Subdivision 45-00. Scott's Pond - Section 2

Staff Report for the August 2, 2000, Development Review Committee Meeting

AGENCY REVIEW COMMENTS
for
S-45-00. Scott's Pond, Section 2

ENVIRONMENTAL DIVISION REVIEW COMMENT
SCOTT'S POND, SECTION 2
PLAN NO. S-45-00
June 30, 2000

Correct
front
setback
must meet
min. lot
width
requirements

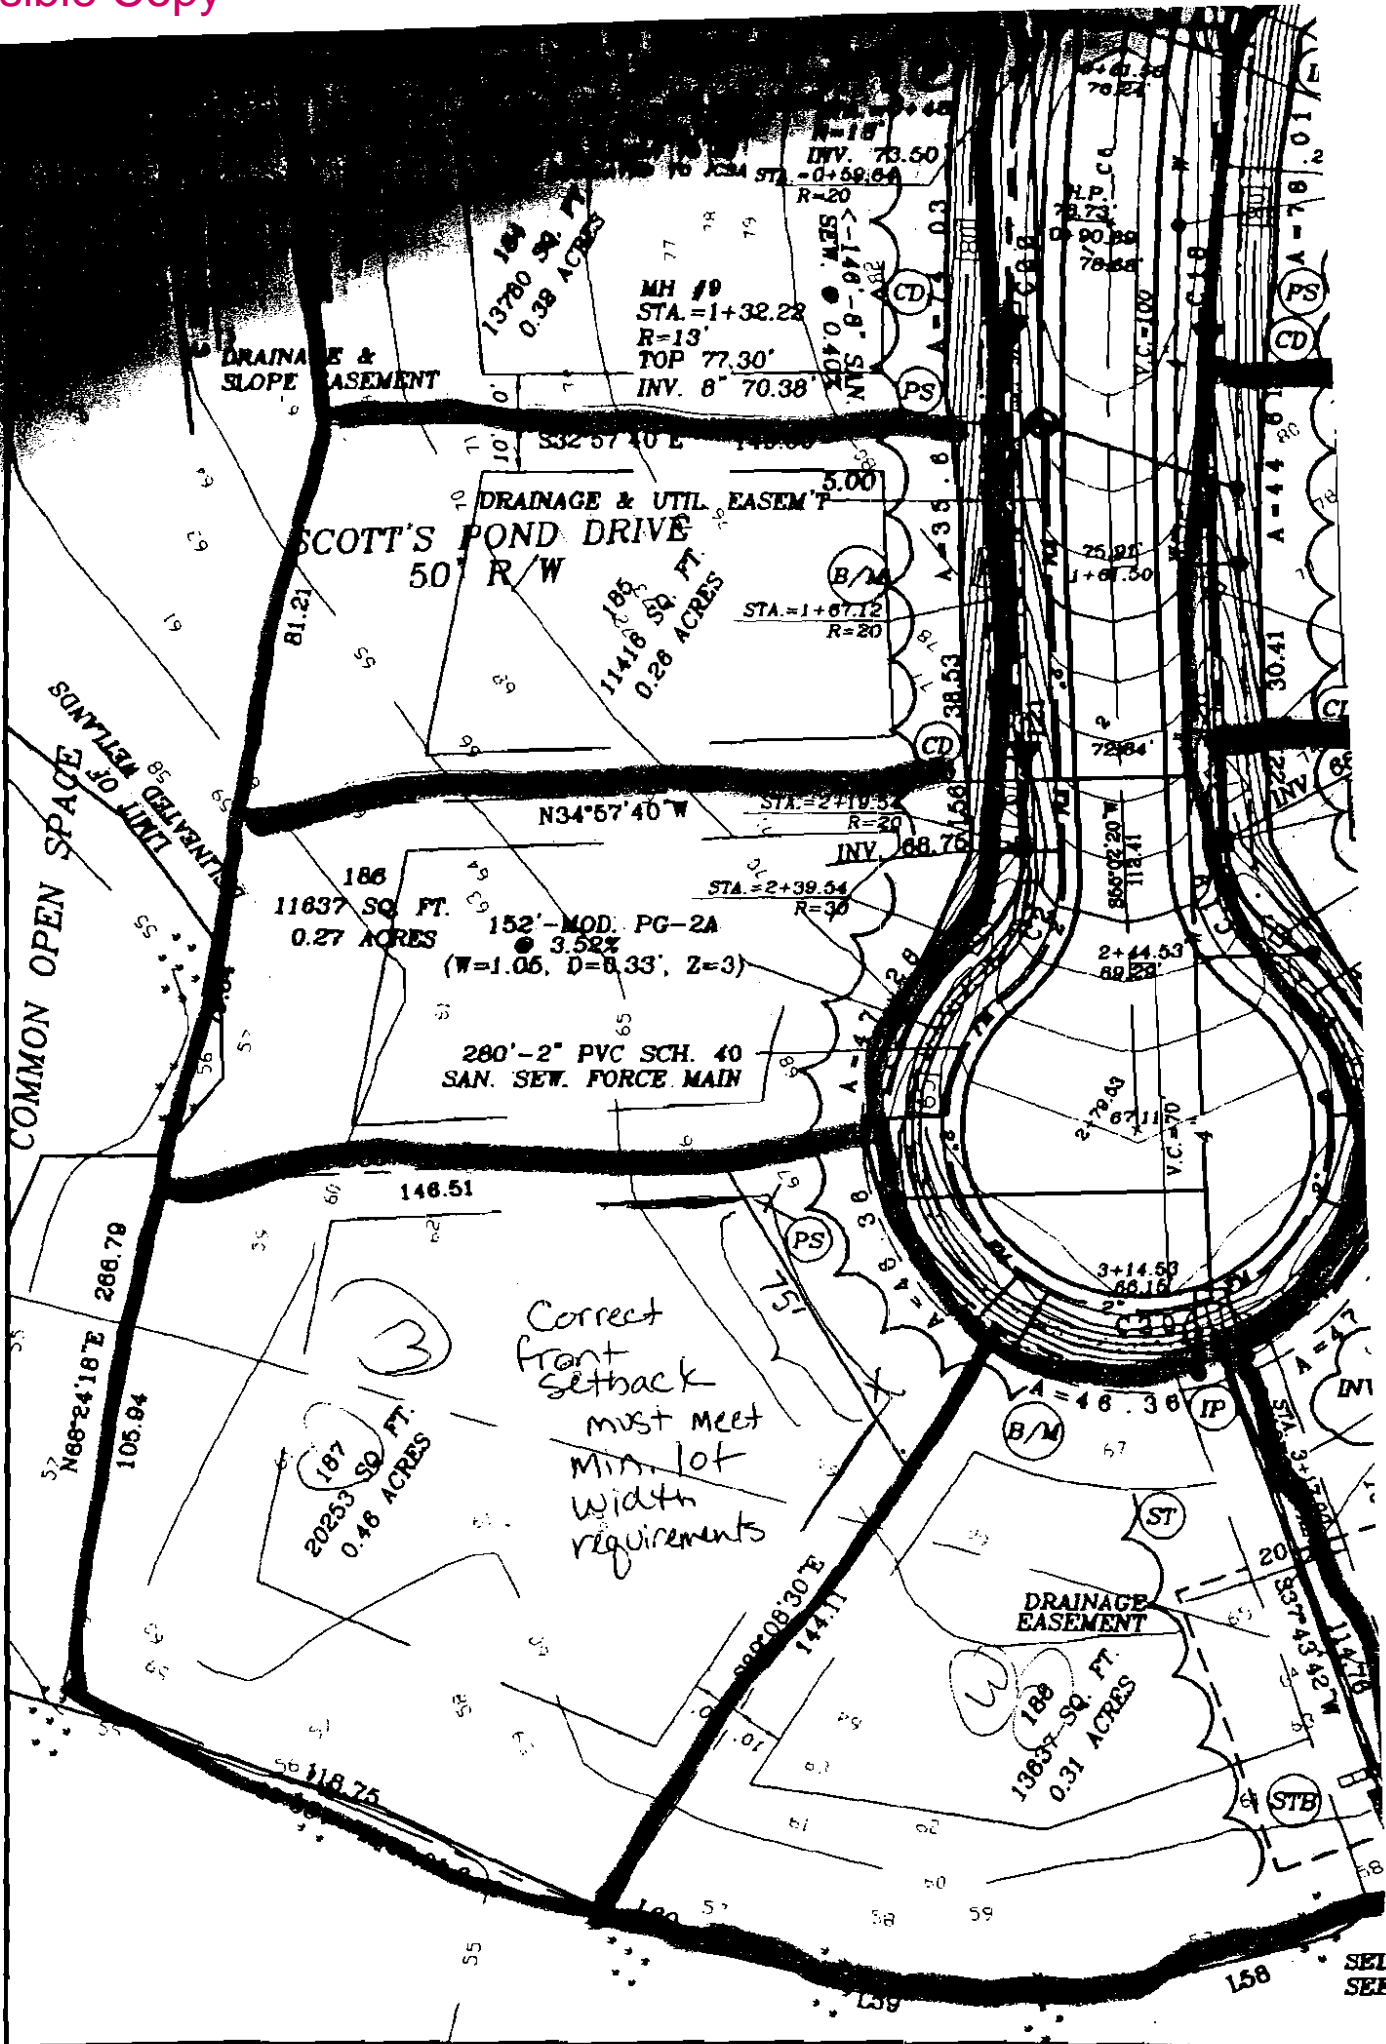
11. Lot numbers: 98, 100, 101, 189, 188, 187, 149, 139, 140, 141, & 116 must have correct front setback lines (see attached typical).
12. Please make sure that Lot 191 has a minimum width of 75' at the front setback line.

13. Please make sure that Lot 126 has a minimum width of 100' at the front setback line.
14. Please correct the rear setback on Lot 152
15. The pump station lot has 15' setbacks from all property lines. Please adjust accordingly.
